CITY OF FRANKLIN
PLAN COMMISSION MEETING*
FRANKLIN CITY HALL COUNCIL CHAMBERS
9229 W. LOOMIS ROAD, FRANKLIN, WISCONSIN
AGENDA
THURSDAY, JUNE 9, 2022, 7:00 P.M.

CITY OF FRANKLIN
REPORT TO THE PLAN COMMISSION
Meeting of June 9, 2022
SPECIAL USE & SITE PLAN

RE: Woodfield Trail- Revised Submittal

FIGURE 1 – PROPOSED FILL AREA

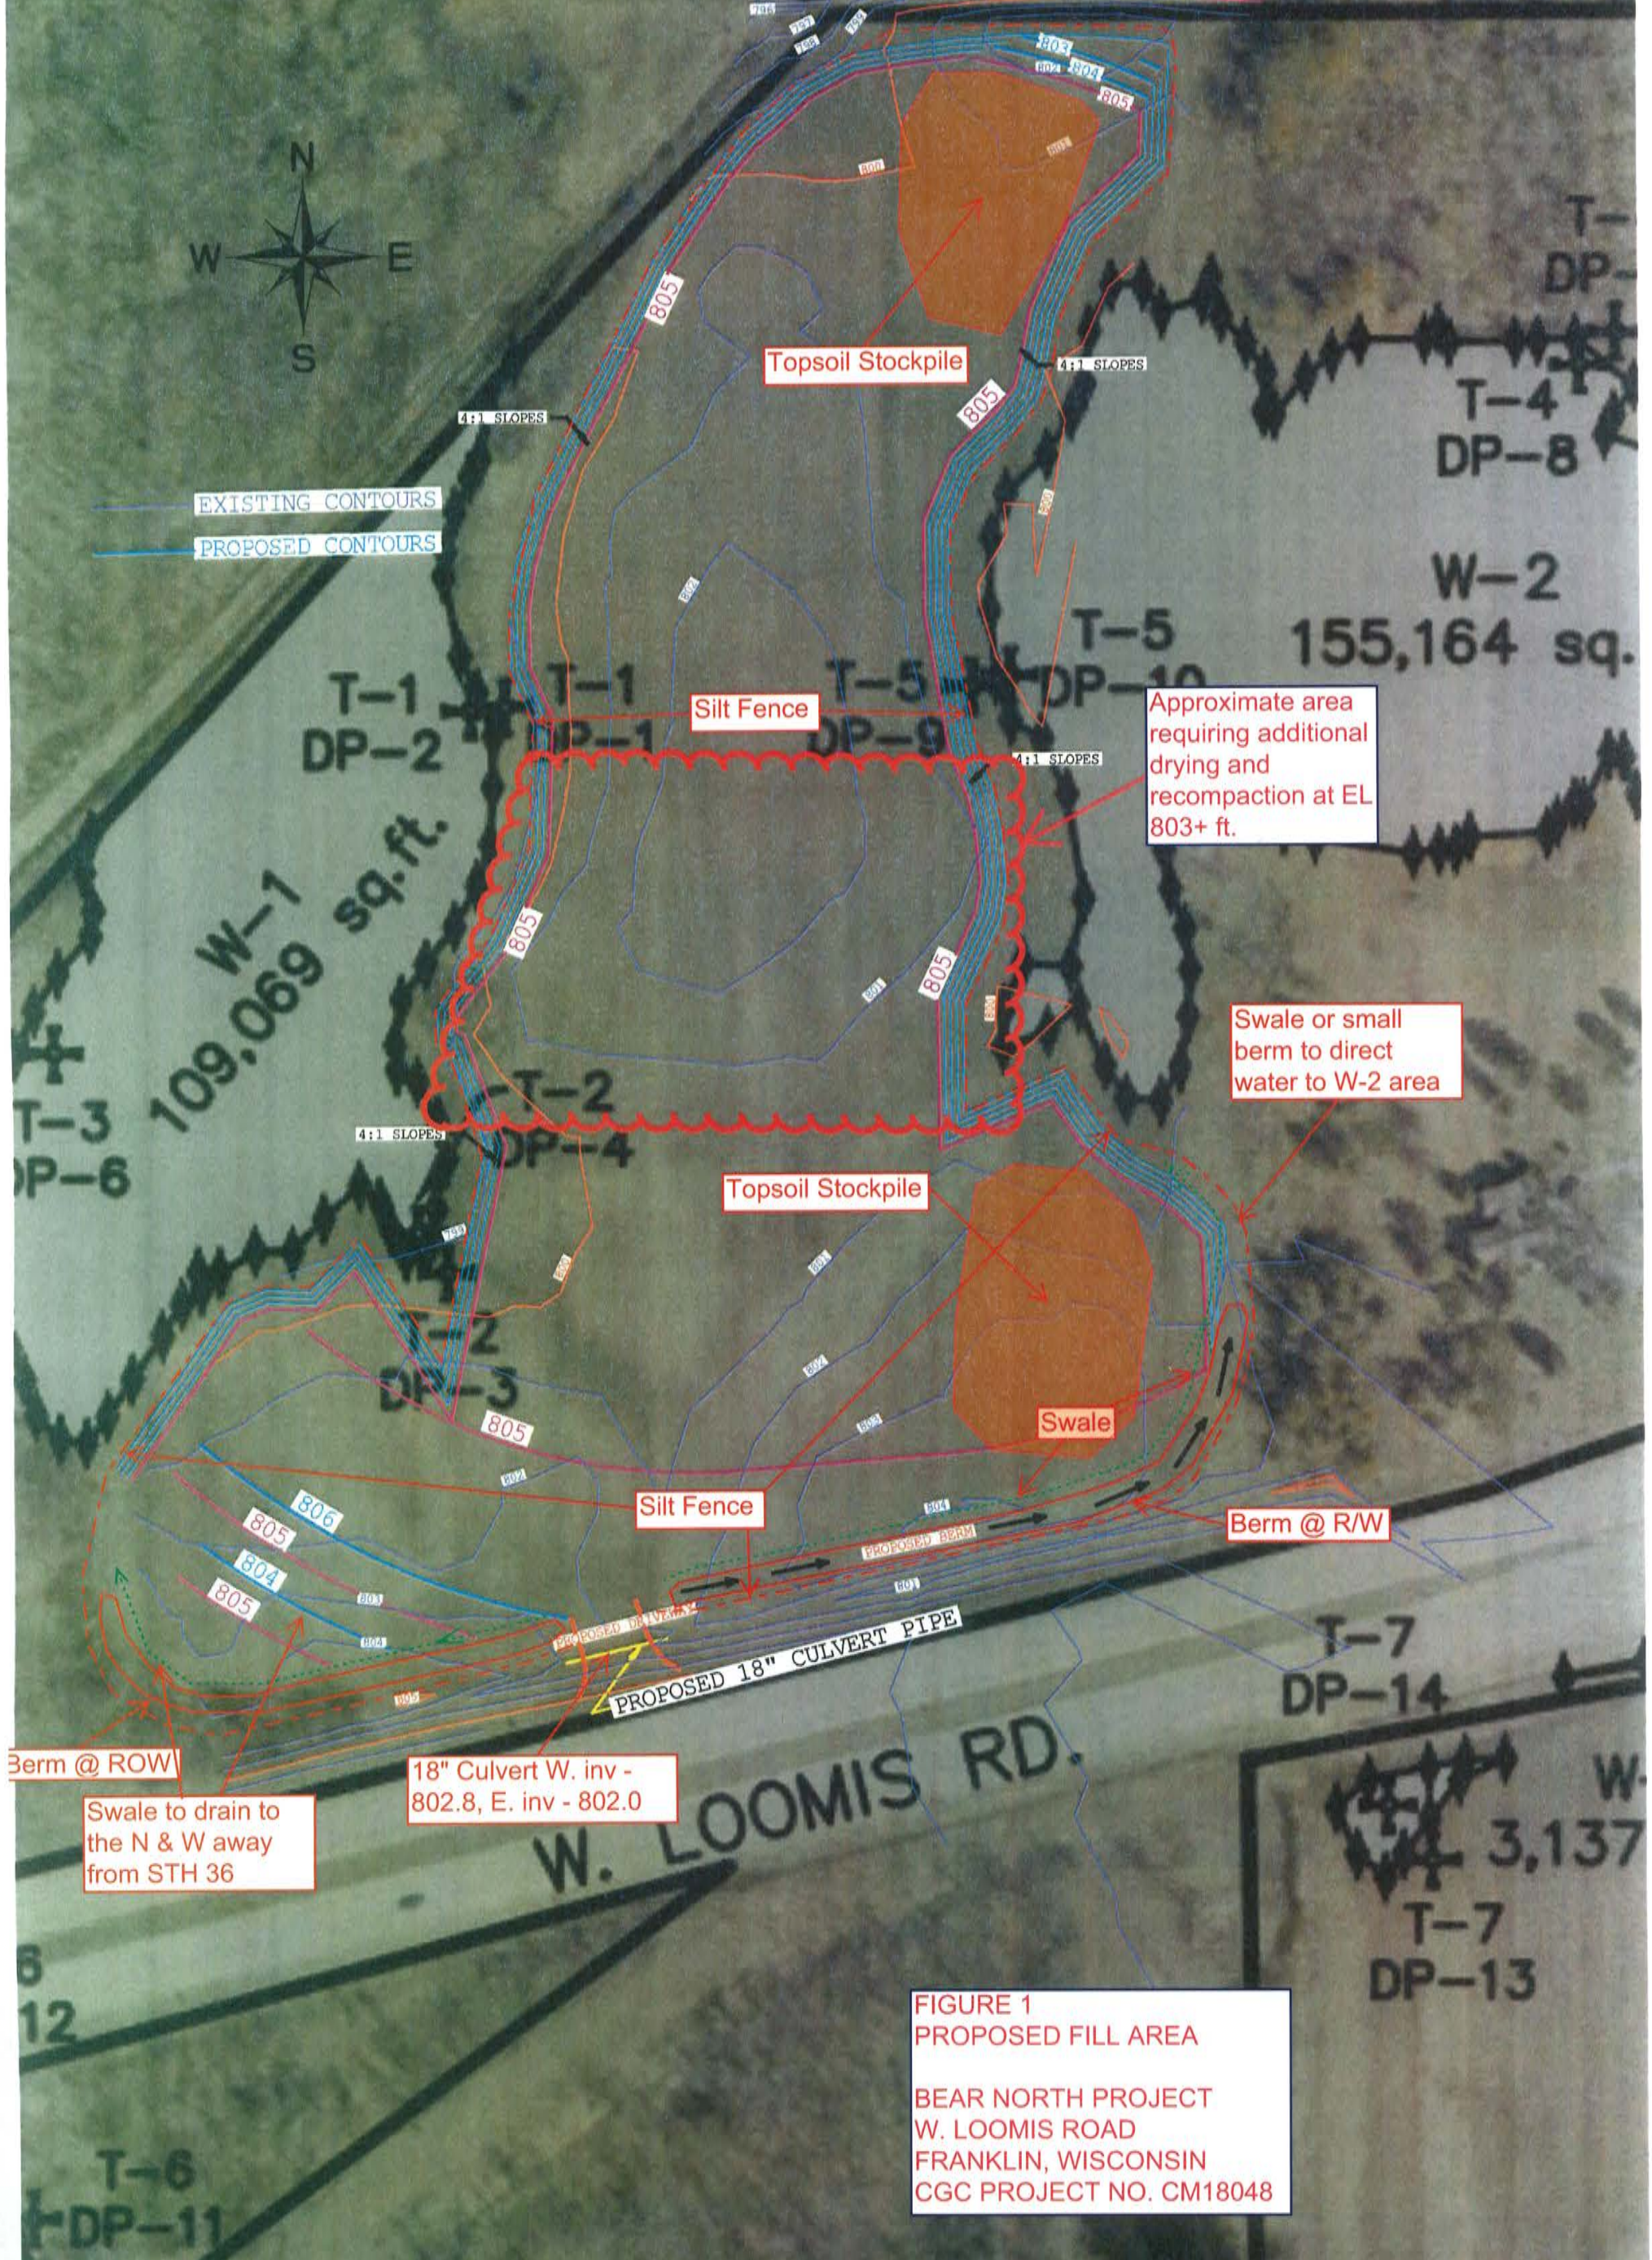
An exception was, however, encountered within the central portion of the site, the approximate limits of which are indicated on Figure 1 enclosed in Appendix A. Within this area, fill soils were placed and adequately compacted to, on average, about EL 802 to 802.5 ft. However, subsequent lifts placed to about EL 803 ft were too wet to properly compact and perform subsequent density tests. It was our recommendation at the time, as communicated to Musson field personnel, and in a subsequent meeting with Musson and Bear Development, that the soils in this area be aerated to promote drying and recompacted until the targeted compaction levels are obtained. However, further site preparation within the central portion of the site has not been performed to-date, due to project scheduling and weather conditions.

Approximate area requiring additional drying and recompaction at EL 803+ ft.

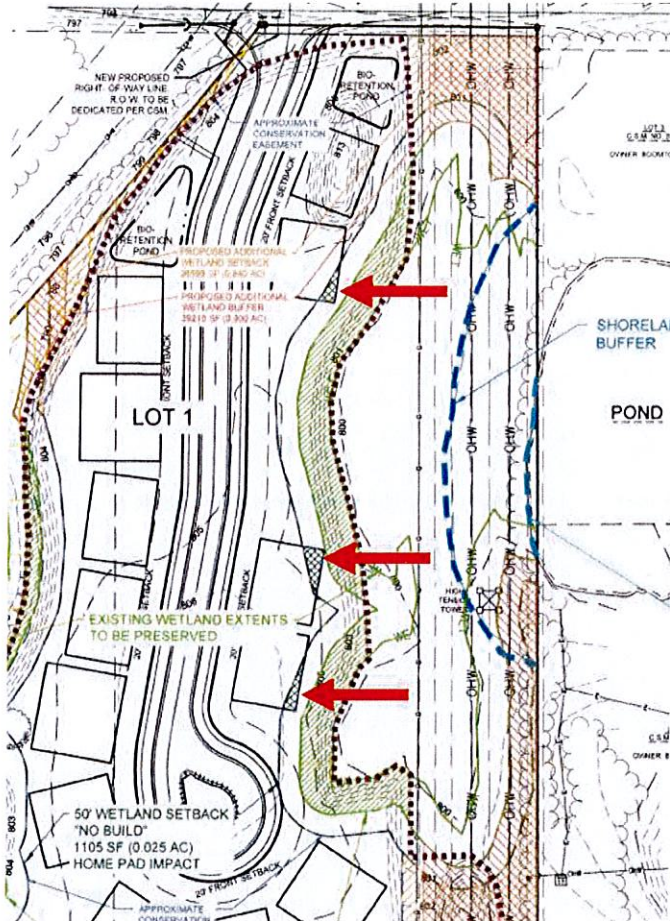
2. **Wetland setback.** Per Natural Resource Special Exception (NRSE); Standards, Findings & Decisions (Doc. 11224509), decision #8 states that “the applicant incurs only temporary impacts to wetland setback and buffer”. In other words, the NRSE did not approve any permanent impact or structures into the 50-foot wetland setback. Please indicate the building footprint of all structures and dwellings to attest compliance with the wetland setback.

The revised Civil Engineering Infrastructure Plans depict the size, location and orientation of proposed building footprints in relation to the wetlands. All building footprints are in compliance with the approved Natural Resource Special Exception.

Figure 15-5.0101
STREET NAMING SYSTEM

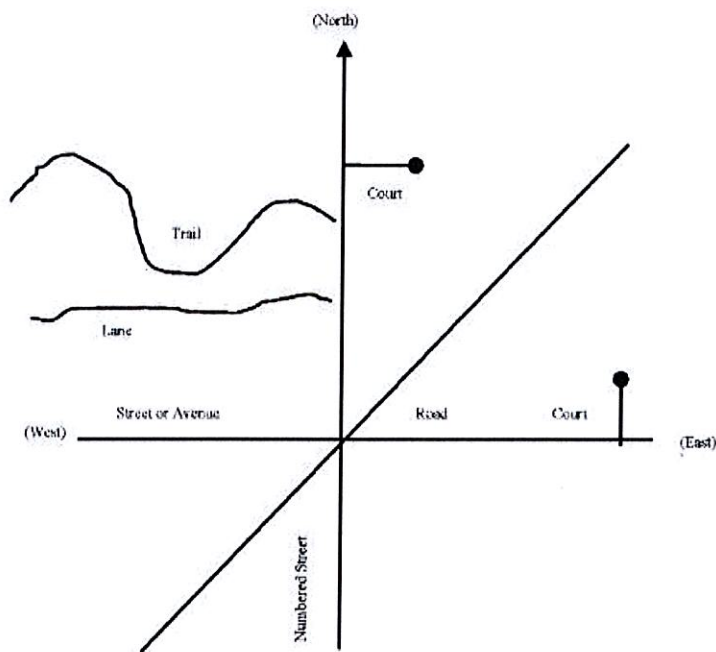
9. **Cul-de-sac street.** Please add length of the proposed cul-de-sac street, measured from the Ryan Road centerline to the center of the island. This length cannot exceed 800 feet per UDO Section 15-5.0103A. Please indicate the name for this street, “Court” is recommended for cul-de-sac streets per the street naming system (UDO Figure 15-5.0101).

Please see page C-10 of the Revised Civil Engineering Infrastructure Plans. The cul-de-sac has a total length of 769 feet and has been named Woodfield Court.

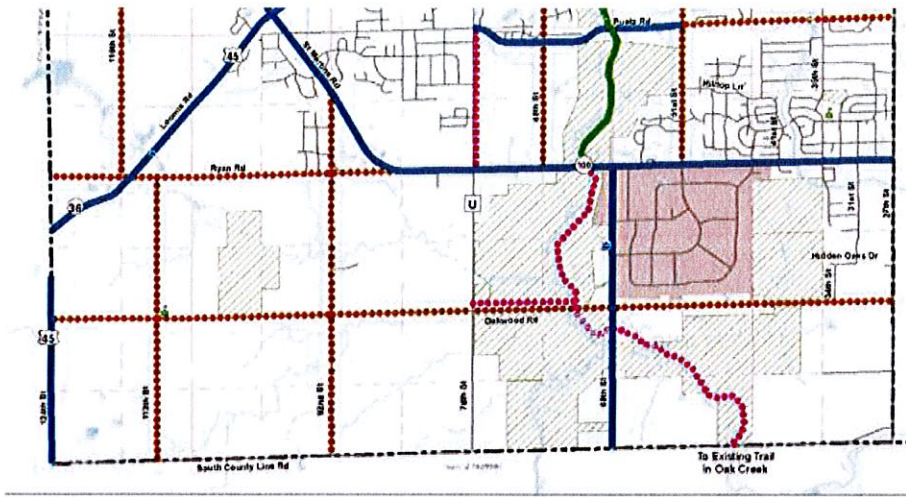
10. **Pedestrian Facility along Ryan Road.** Based on the Comprehensive Master Plan, Map 7.4 Bicycle and Pedestrian Circulation Facilities. City Development staff recommends the installation of a pedestrian path per City of Franklin specifications on the south side of Ryan Road, from the new sidewalk on the east side of the proposed cul-de-sac street to the eastern boundary of the subject site.

Please see page C-16 of the Revised Civil Engineering Infrastructure Plans. Bear Development seeks direction from the City as to whether the future trail is to be shown in
